**300 ULLOA STREET  
13-UNIT RESIDENTIAL DEVELOPMENT  
Final Environmental Impact Report  
90.079E**

File No.: 90.079E  
Address: 300 Ulloa  
Street  
Assessor's Block 2876,  
Lot 7

SAN FRANCISCO  
CITY PLANNING COMMISSION  
MOTION NO. 13083

Figure 13 - Photograph -- View of Project Site Looking North from Portola Drive-Rex Avenue Intersection from Developed Area of Mount Davidson

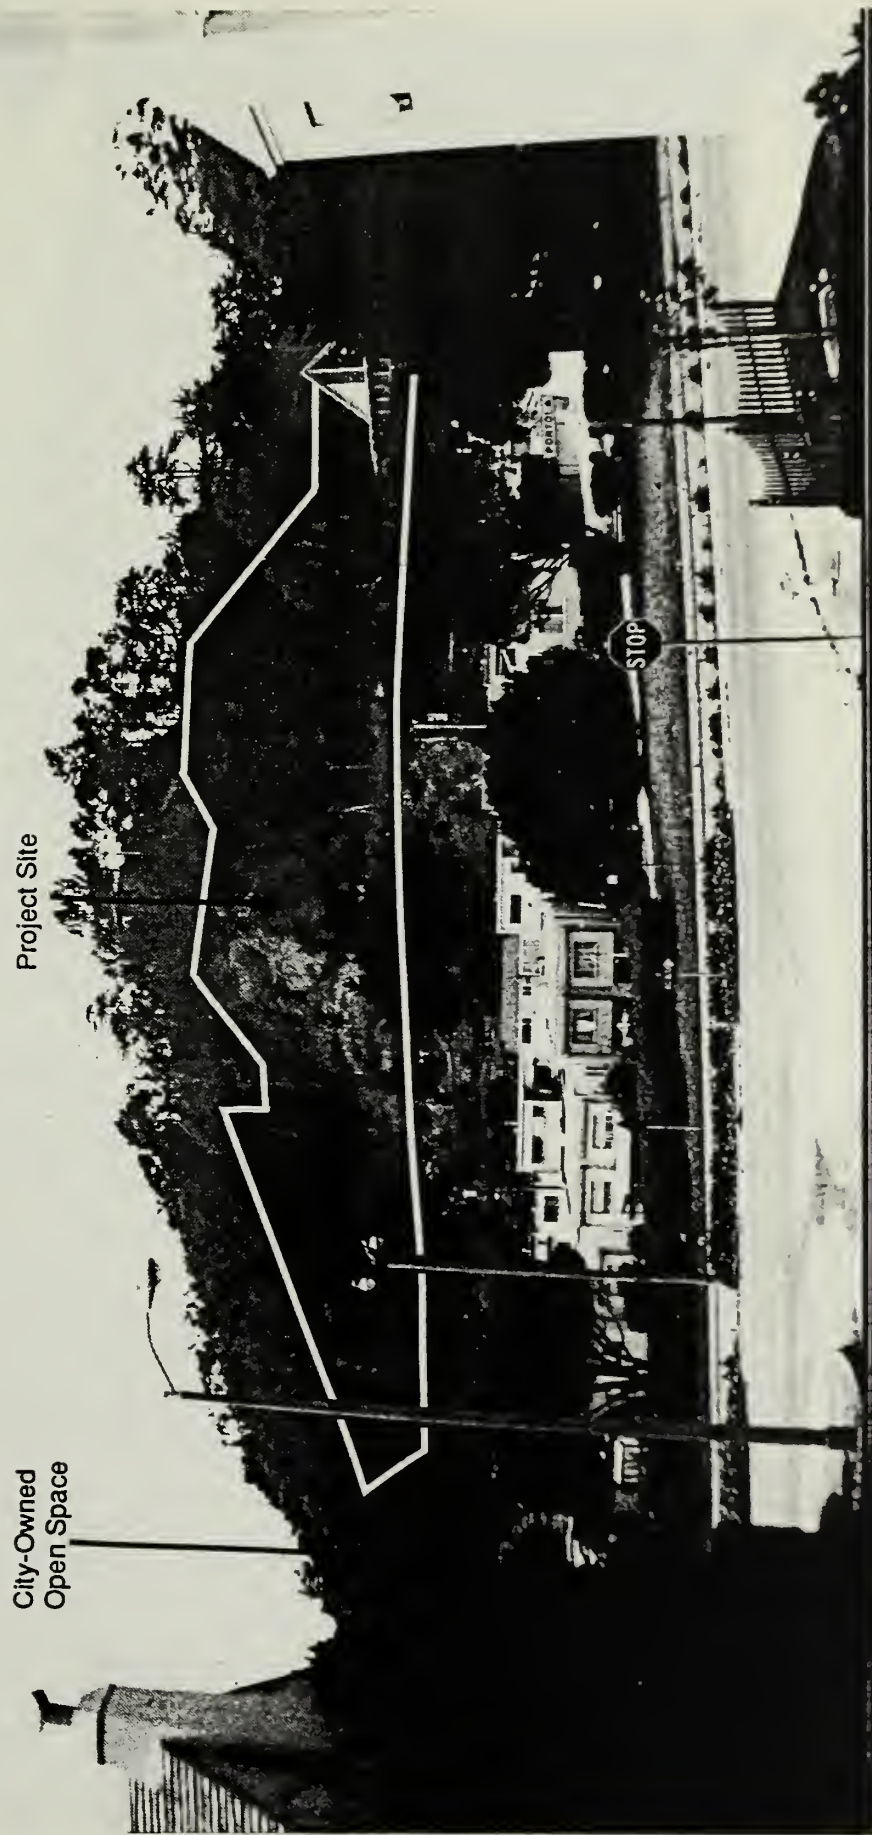
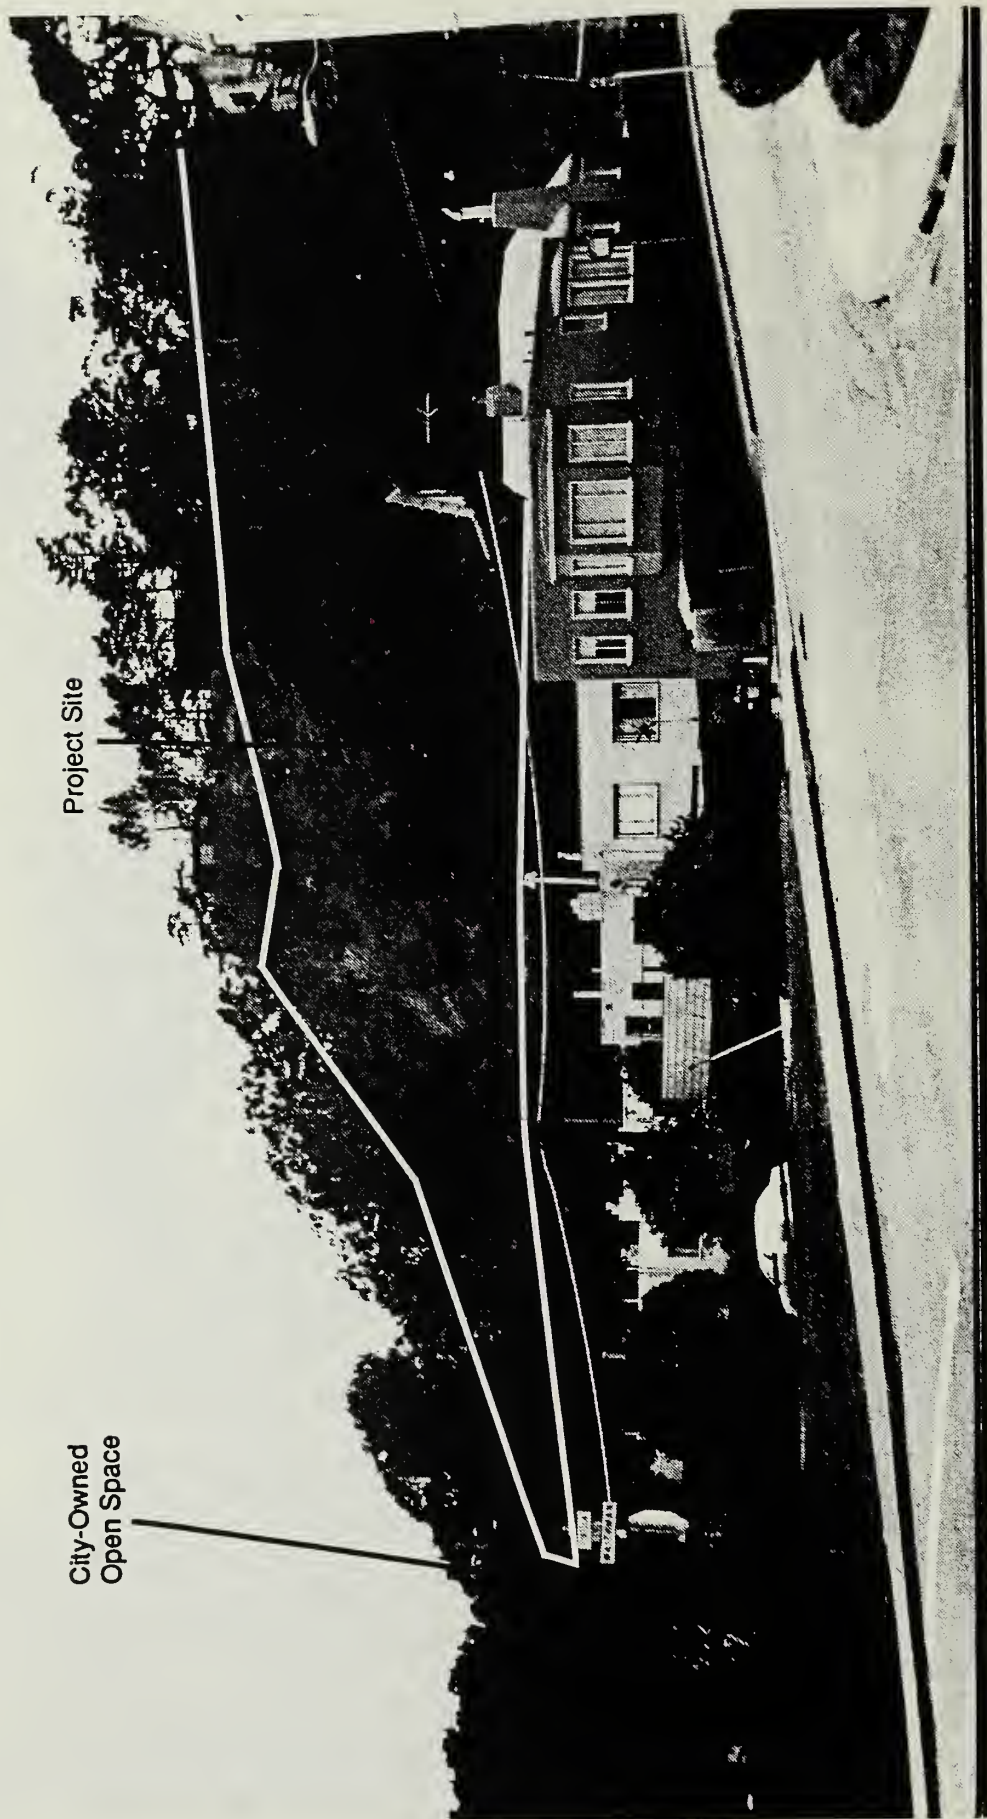
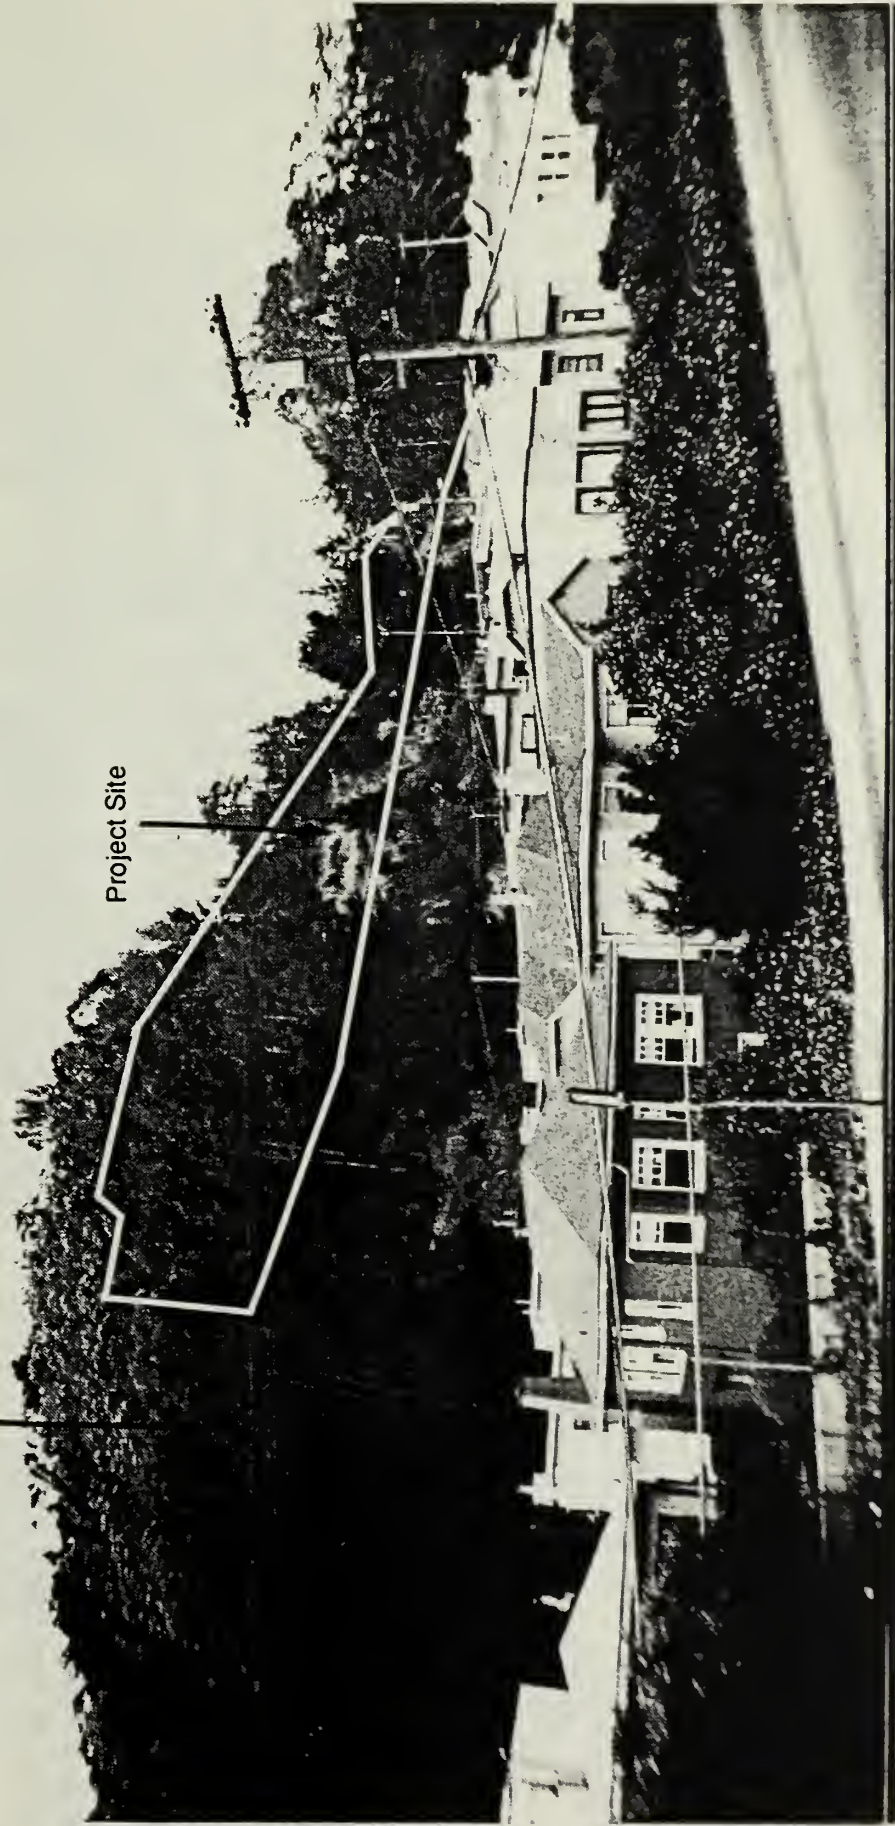
"I'm just going through this because this is bordering public open space, which really was bought by Rec and Park not for hiking, not for anything except its visual -- mostly, it was bought for its visual beauty. And I want this project somehow to relate to that. And ripping out 120 some trees -- this document doesn't make it clear how that's going to affect the open space. So I'm just trying to get at places where it might be appropriate to do more." (Susan Bierman, San Francisco Planning Commission)

Figures 13, 14, and 15, pages C&R 13-15 herein, have been revised to demarcate the site and the adjacent public open space and will replace Draft EIR Figures 13, 14, and 15, pages 42-44. Figure 17, Draft EIR page 66 and page C&R 16, has been revised to add more specific information about where trees would be removed, retained,
